NAME OF PROJECT: **Settlement at Gruene**; Located on the west side of Rock Street approximately 900 feet north of its intersection with Loop 337; New Braunfels, Texas

TYPE OF PLAN: Request for Approval of a **Water Pollution Abatement Plan (WPAP)**; 30 Texas Administrative Code (TAC) Chapter 213 Edwards Aquifer

This letter is in response to the fax received 01/16/2016 from The Texas Commission on Environmental Quality/ Edwards Aquifer Protection Program Division as it pertains to The Settlement at Gruene Project. The comments received are in italics and our responses are in bold.

WPAP SITE PLAN

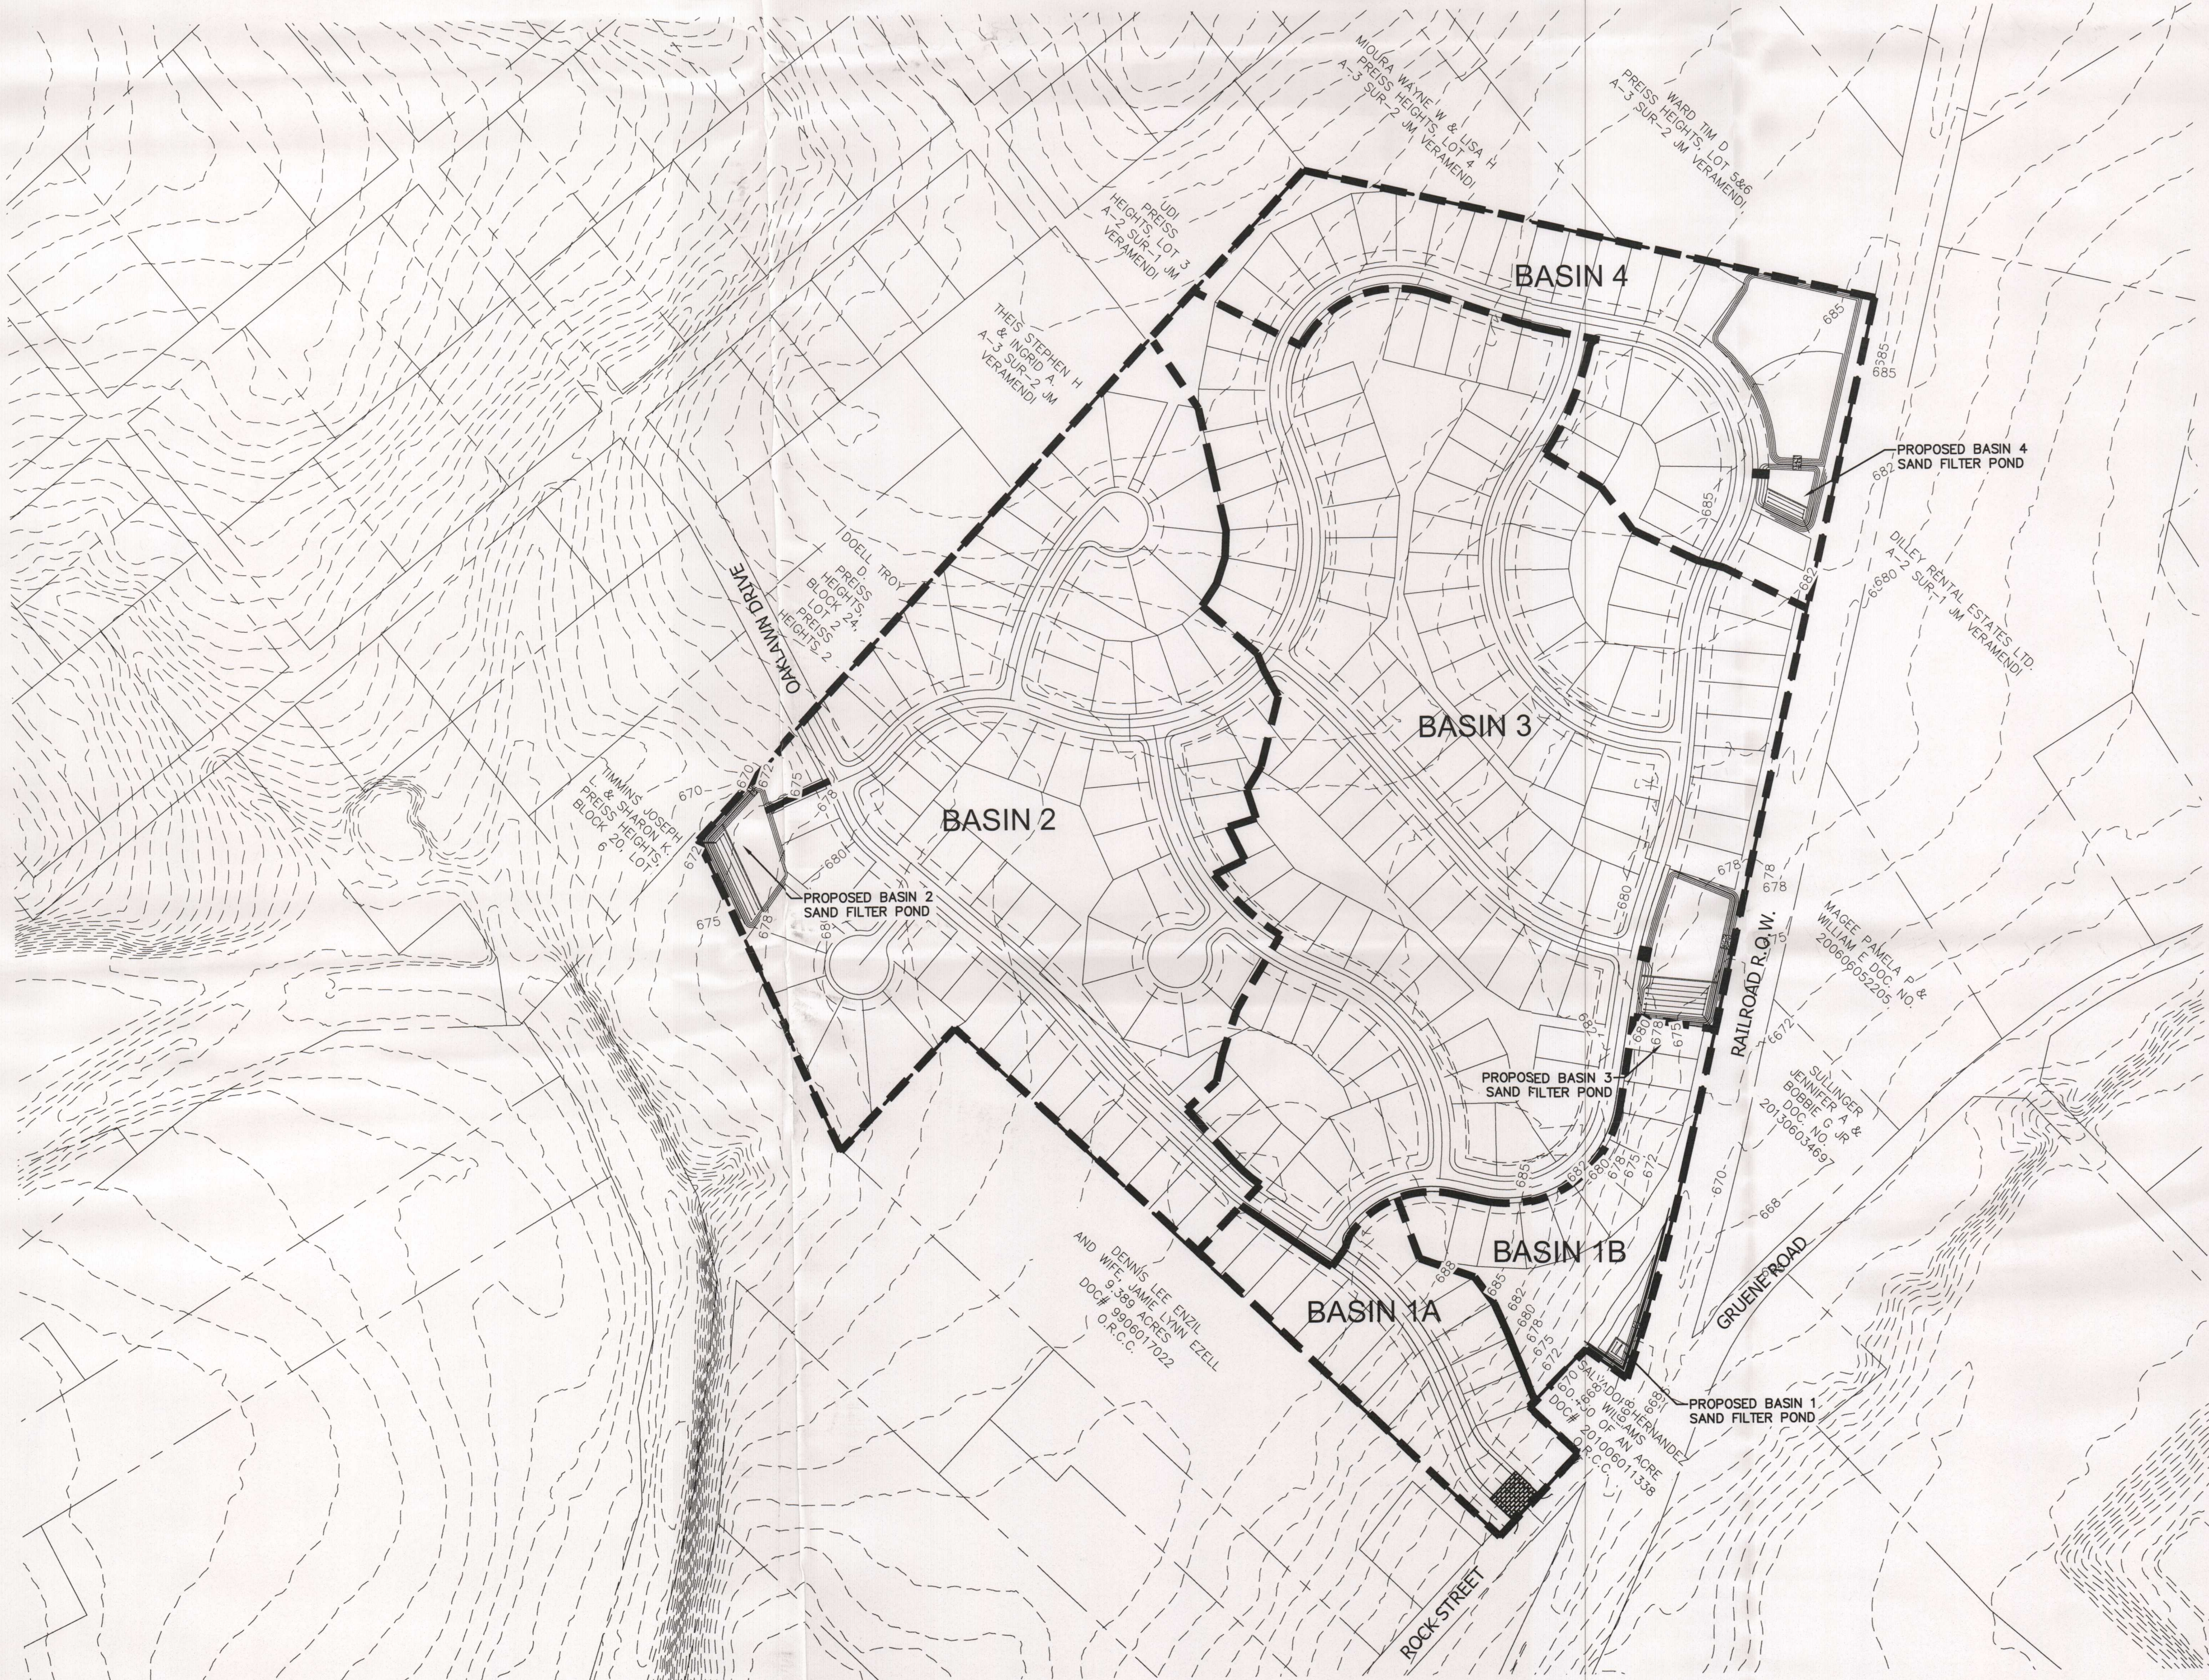
- 1. The WPAP site plan exhibit that was submitted with the application does not specifically show how stormwater will drain to and enter the proposed sand filter basins. Will storm drains be installed to capture and direct the stormwater to the basins? If no storm drains are being proposed, where will the stormwater enter the proposed basins? Please update the site plan exhibit to include any additional proposed stormwater conveyances or update the site plan with additional contour and basin inlet details to show how the stormwater will be directed to and enter the sand filter basins.*
Additional detail has been added to the WPAP Site Plan. Please see attached.

WPAP - DRAINAGE BASIN
MAP

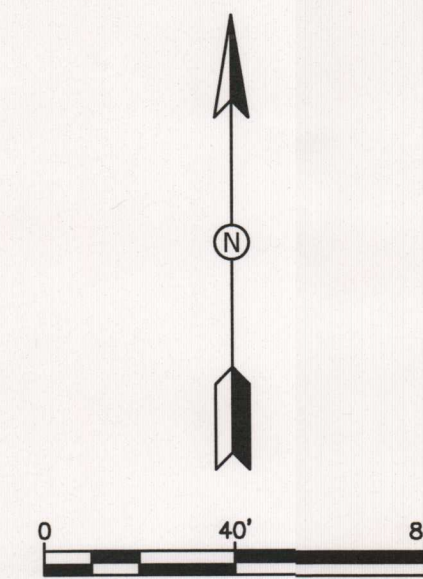
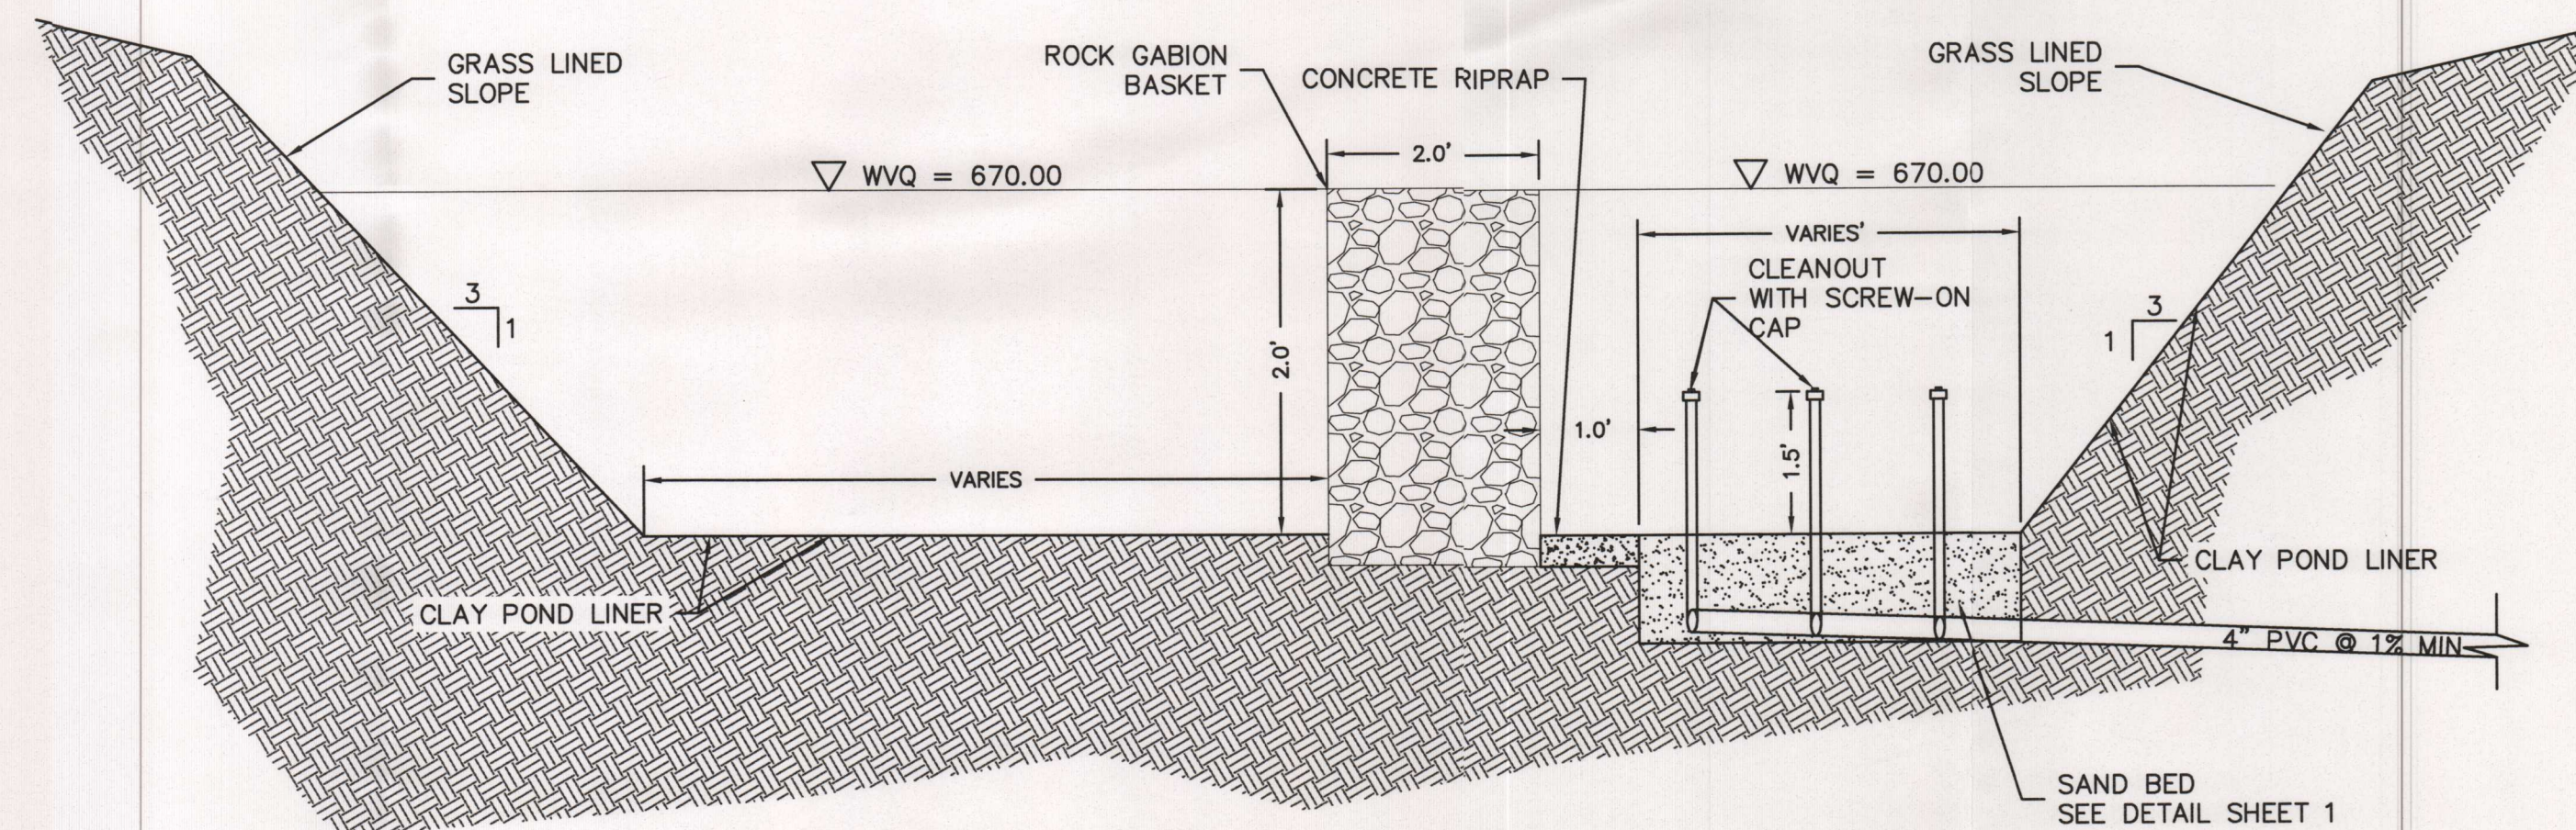
- 3. The 8.5 x 11 drainage area map that was included at the end of the temporary stormwater section only shows two drainage areas but the WPAP Basin Drainage Basin Map shows four separate drainage areas. Please update and resubmit the 8.5 x 11 drainage area map to display the correct drainage areas and acreages.*
The intent of the drainage area map attached to this section is to show the two main drainage divides within the proposed property. The WPAP Basin Map is intended to provide additional detail for onsite drainage area and establish treatment areas for each basin.

WPAP - POND DETAILS

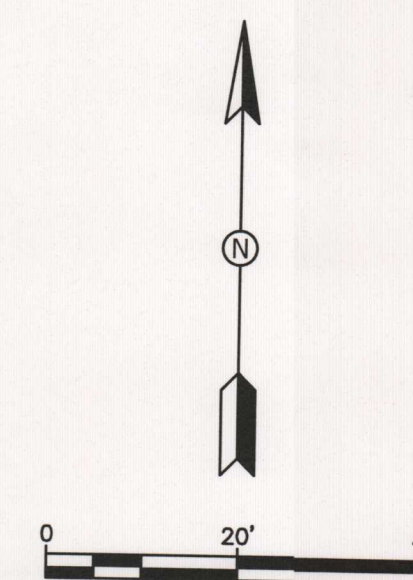
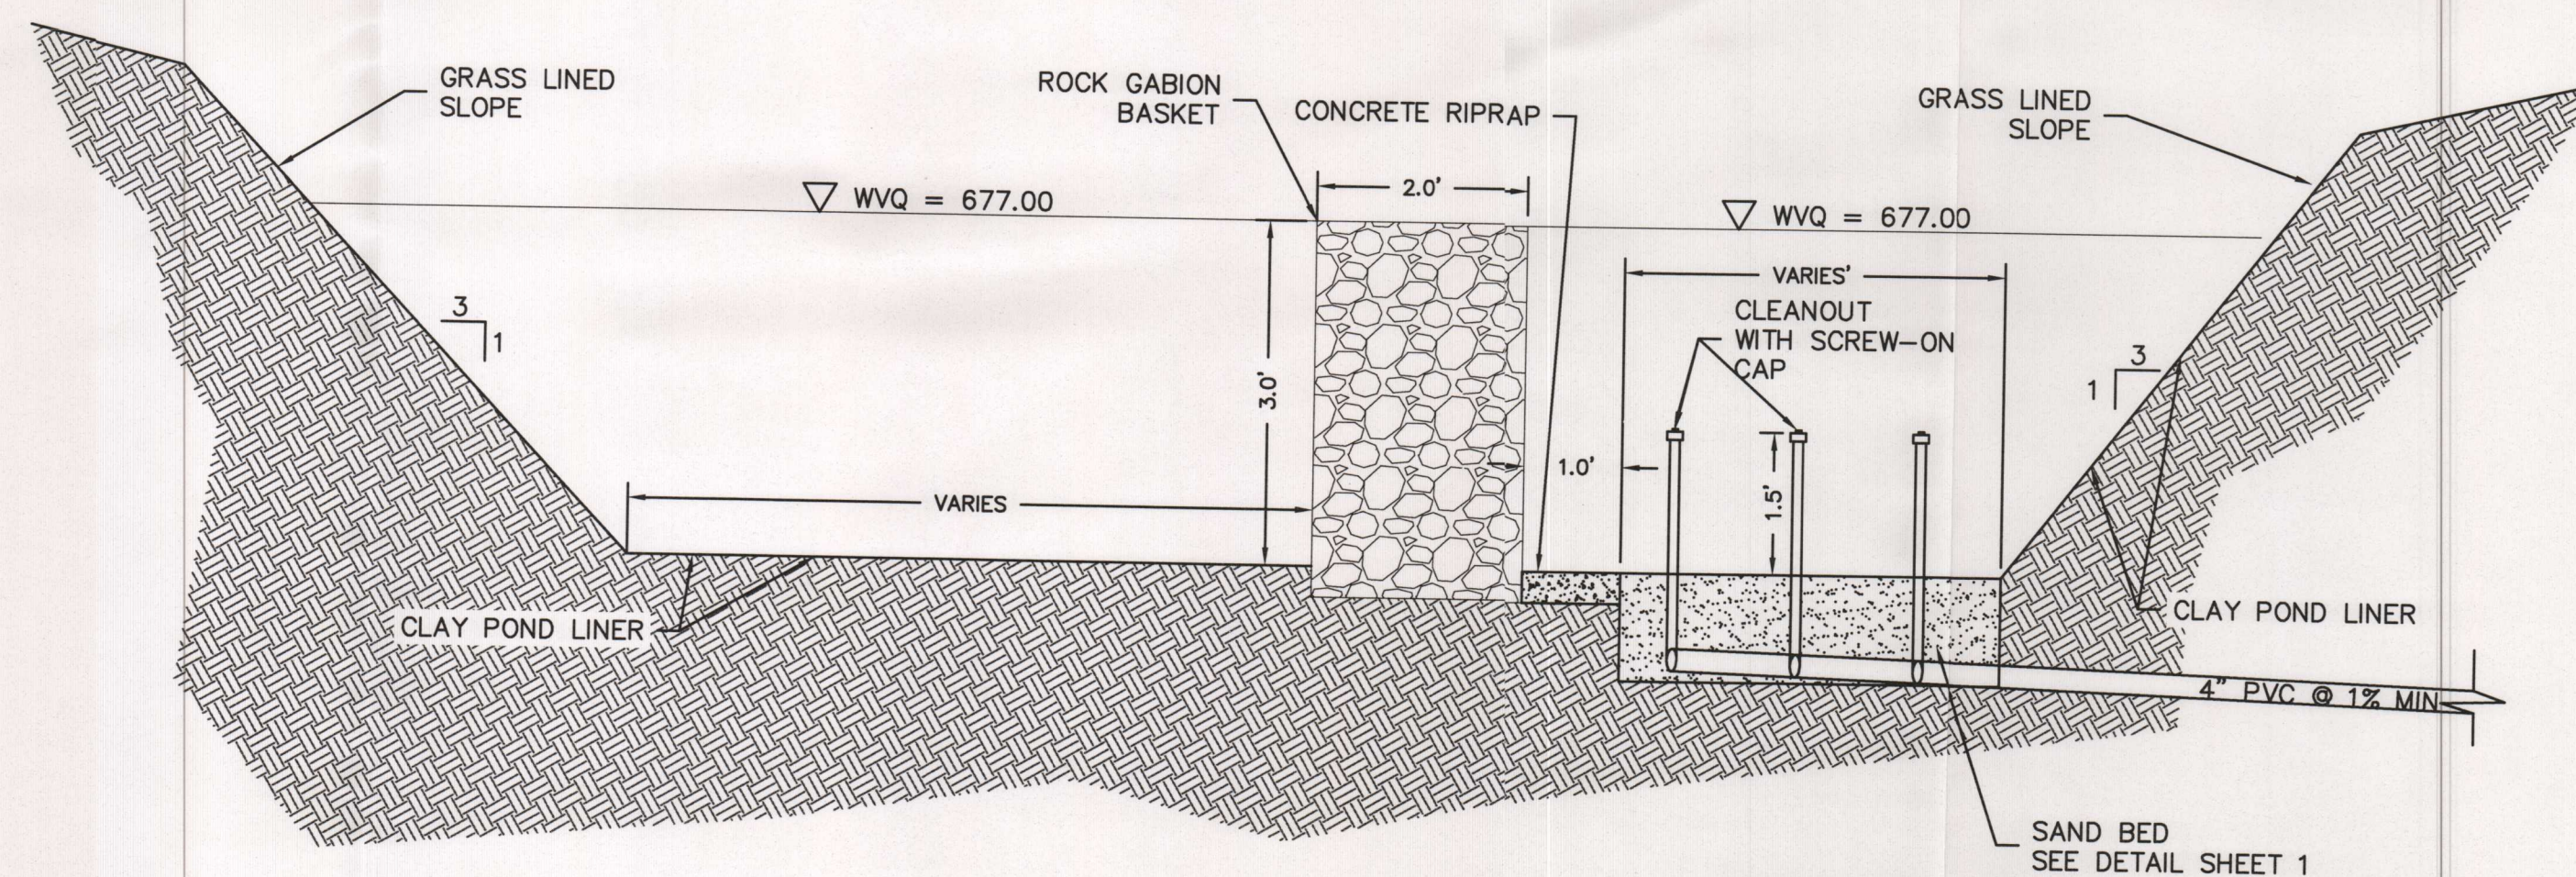
4. *The WPAP Pond Detail schematic sheet does not show the locations where the sediment depth markers will be placed within the basins. The WPAP drainage basin map shows an image of a sediment depth marker but does not detail where it will be placed within each basin. Please update the WPAP Pond Detail schematic sheet to include the placement locations of the sediment depth markers.*
Sediment depth marker locations have been identified in the revised detail sheets.

5. *The WPAP Pond Detail and the WPAP Drainage Basin schematic sheets infer that at least 18 inches of sand will be used but does not describe the specifications of the type of sand. ASTM C-33 fine aggregate sand is the required specification for the sand media. Please update the design sheets to include the sand media specifications.*
Note has been added to the plan sheets.

6. *The WPAP Pond Detail sheet and the sand bed profile, displayed on the WPAP Drainage Basin Map, show that an impermeable liner will be used but it does not specify which type of impermeable liner is proposed. However, specifications for a clay liner were provided on the Drainage Basin Map sheet. Please verify the type of impermeable liner that will be proposed for each of the four basins. If possible, please add the proposed liners to the cross sections (section AA) for each basin.*
Additional detail has been added to the sections for each pond.

7. *According to the WPAP Pond Detail schematic sheet, sand filter basins 1,2,and 4 have fewer than 3 underdrain pipes. According to RG-348, complying with the Edwards Aquifer Rules; Technical Guidance on Best Management Practices, "The underdrain piping should consist of a main collector pipe and two or more lateral branch pipes, each with a minimum diameter of 4 inches. The pipes should have a minimum slope of 1% (1/8 inch per foot) and the laterals should be spaced at intervals of no more than 10 feet. There should be no fewer than two lateral branch pipes." Please update the sand filter basin designs to meet the design parameters listed in RG-348.*
Underdrain piping has been revised.

8. *According to the WPAP Pond Detail schematic sheet, the proposed flow splitter for the sand filter basins will be an overflow weir located within an earthen sidewall of the basins. The specific elevations of the overflow weir structure and the tops of the earthen walls were not included on the sheets. Please update the schematic sheets to include the spillway elevations and upper wall elevations of the weir structure as well as the surrounding earthen wall elevations for each basin.*
Additional detail has been added.

10. *The cross section AA listed on the WPAP Pond detail schematic sheet appears to be a general representation of each basin and does not show specific details for each basin such as; the water quality volume elevation, stormwater inlet characteristics (velocity dissipation, etc.), weir overflow structure, maintenance access structure, security fence (if proposed), etc. Please update the WPAP Pond Detail sheet to display the cross sections of each basin to include the specific water quality volume elevation, inlet structure(s), velocity dissipation, erosion prevention riprap, weir overflow structure & elevations (if applicable), maintenance access locations, etc.*
Additional detail has been added to the sections.

11. *According to the WPAP Pond Detail sheet the proposed maintenance access will be located within the side walls but the details for this access were not included in the drawings. Cross section AA of this*

sheet shows the slope of the basin side walls as 3 to 1 (33.33%). This slope exceeds the maximum recommended slope for maintenance access drives as listed in RG-348. Please revise the detail sheet to provide additional detail for each proposed maintenance access drive. Please ensure these maintenance access drives conform to the recommended design criteria as listed in RG-348.

12. The individual basin outfall isolation valve locations were not included on the WPAP Pond Detail sheet. Please update this sheet to include the locations of the required isolation valves for each basin.

13. According to the WPAP Pond Detail sheet it appears that the basin outfall for basins 2,3, and 4 will discharge offsite and the outfall for basin 1 will discharge into its associated detention basin. Please explain how erosion will be prevented at the outfall discharge points for each basin. If velocity dissipation will be proposed, please update the schematic drawings to include these structures.

14. The WPAP Pond Detail and the WPAP drainage basin sheets do not show the outfall structures proposed for the detention ponds associated with basins 1,3, and 4. Please update the schematic sheets to show the outfall structures and any proposed erosion control measures for these detention ponds.

15. The basin sizing and design values listed on the bottom of the WPAP Pond Detail sheet appear to be incorrectly displayed. The four proposed sand filter basins have rock gabion walls separating the sedimentation and filtration chambers. These types of basins are classified as partial sedimentation designs but the classification and minimum sizing values displayed in the listed chart are for full sedimentation designs. Based on proposed design criteria the value chart should be displayed as follows:

Maintenance ramp locations have been included in the revised plan sheets.

Isolation valve locations are shown in the revised plan sheets.

Additional detail is included in the revised sheets.

Additional detail is included in the revised sheets.
